**PLANNED UNIT DEVELOPMENT
& SUBDIVISION STAFF REPORT****Date: December 2, 2010****DEVELOPMENT NAME**

Hillcrest Plaza Outparcel Subdivision

Planned Unit Development Approval to allow multiple buildings on a single building site with shared access and parking between multiple building sites, and Subdivision approval to create 1 lot.

SITE PLAN

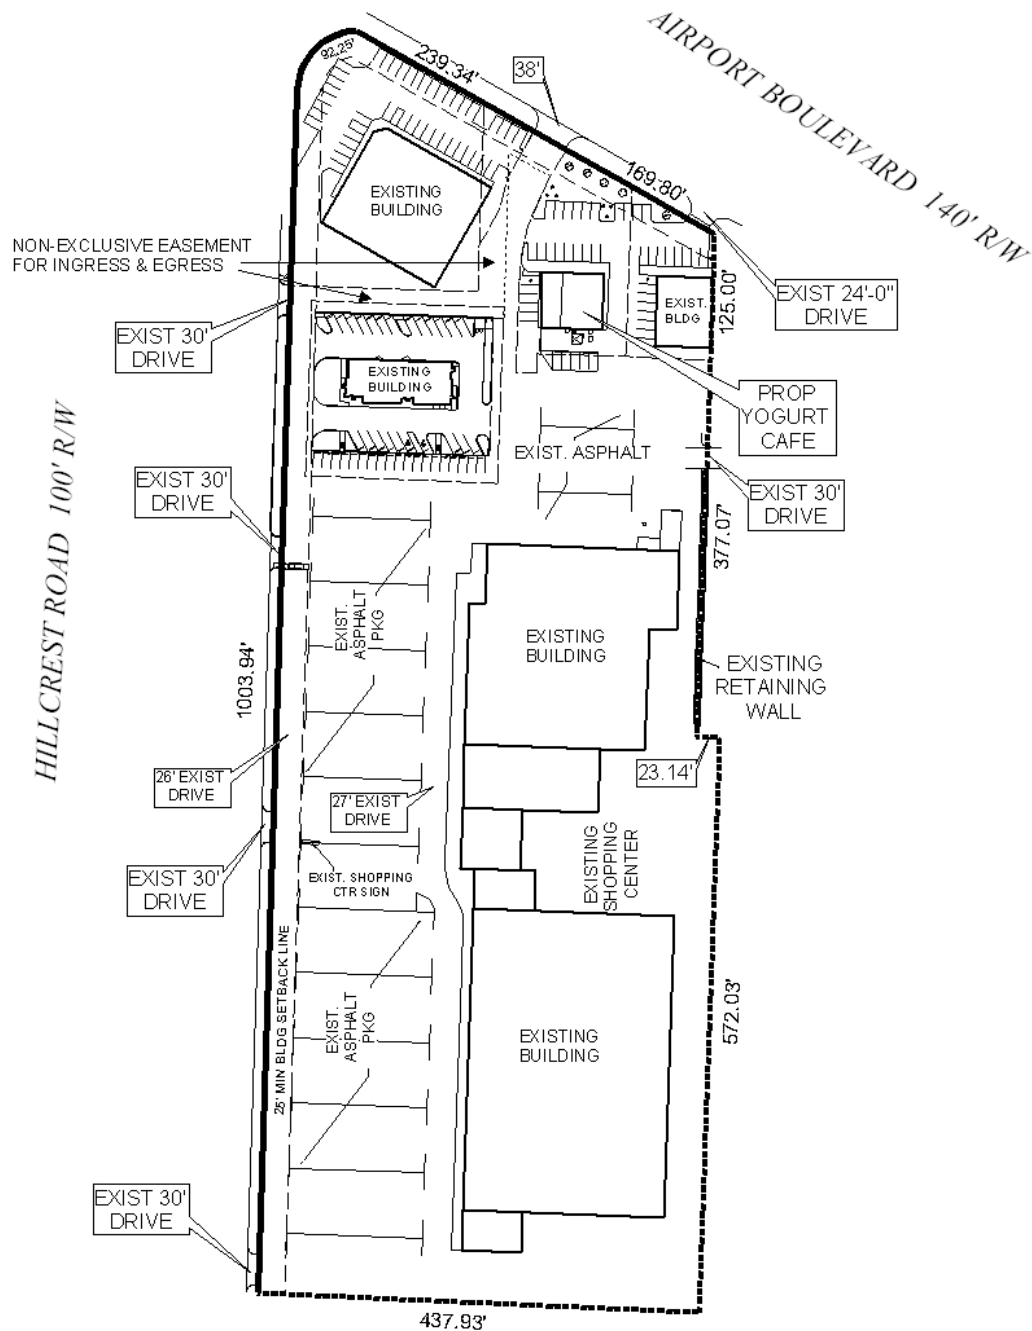
As a new restaurant is proposed, a new dumpster will be provided behind the restaurant building. The site plan indicates that it will be enclosed, as required.

The proposed lot has a sidewalk crossing half of the lot's frontage along Airport Boulevard. Staff recommends that the remaining half of the sidewalk be completed, so that it can connect with the new sidewalk that was built when then Walgreen's drug store was constructed.

The proposed lot has one existing curb-cut onto Airport Boulevard, and shared access to adjacent lots that are part of the associated PUD. The lot should be limited to its single existing curb-cut, with any changes to its size or design to be approved by Traffic Engineering, and to conform with AASHTO standards. Should applicant wish to relocate the curb-cut, a new PUD application will be required. Overall, the PUD should be limited to its two existing curb-cuts onto Airport Boulevard and its four existing curb-cuts onto Hillcrest Road.

- 3) Placement of a note on the site plan stating that the site is limited to the existing curb-cuts, with any change to the location of the curb-cuts requiring a new PUD application;

- 4) Placement of a note on the site plan stating that modification of the size or design of any curb-cuts is subject to the approval of Traffic Engineering, and must comply with AASHTO standards;
